Technical Note

Project:	Finchwood Park Parcels 11 & 12	SMA Ref:	7292.TN09
Subject:	Response to WBC Landscape Comments	Revised:	B – 16.10.2025
Prepared by:	Tyler Andrews	Date:	06.08.2025
Checked by:	Kate Marshall	Date:	07.08.2025

DRAWING TITLE
PARCEL 11 AND 12 PROPOSED LEVELS SHEET 2 OF 2

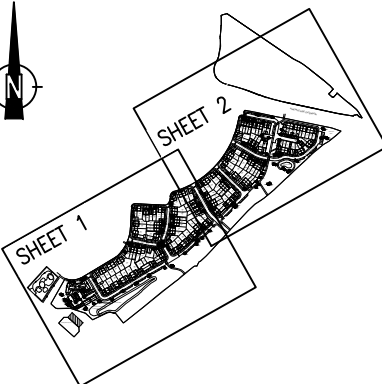
The FFLs of the three storey apartment blocks on the western side of the development parcel appear to be over 1.5m above existing ground levels with the two-storey block 1m above existing. The proposed ground levels around this part of the site will need to be indicated on the levels plan to show how the proposed levels will grade back into the existing and how these relate to the adjacent public open space.

Further levels information has been added in the form of banking and spot levels, to clarify how the proposals tie into the surrounding existing ground levels. It should be noted that the Parcel 10 road to the north is significantly higher than existing levels and the proposals must tie into this, hence the floor levels of the apartment blocks being raised accordingly.

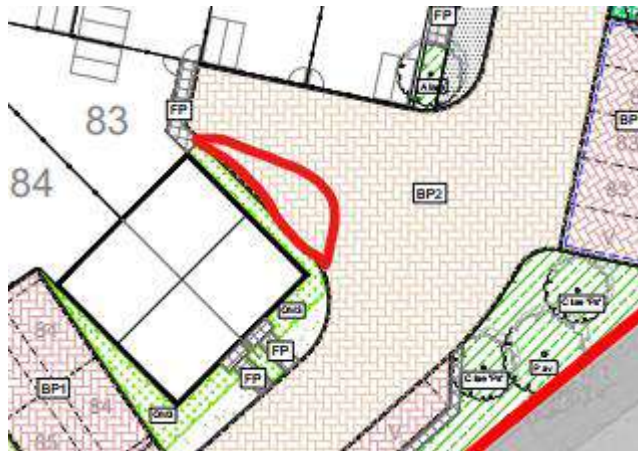
4. The turning head between plots 82 & 83 is excessively wide to the front of this area. I suggest the hardstanding is reduced by the red line in the extract below to enable more planting in this location. I have checked the vehicle tracking and this area seems to be outside what is required for refuse vehicles.
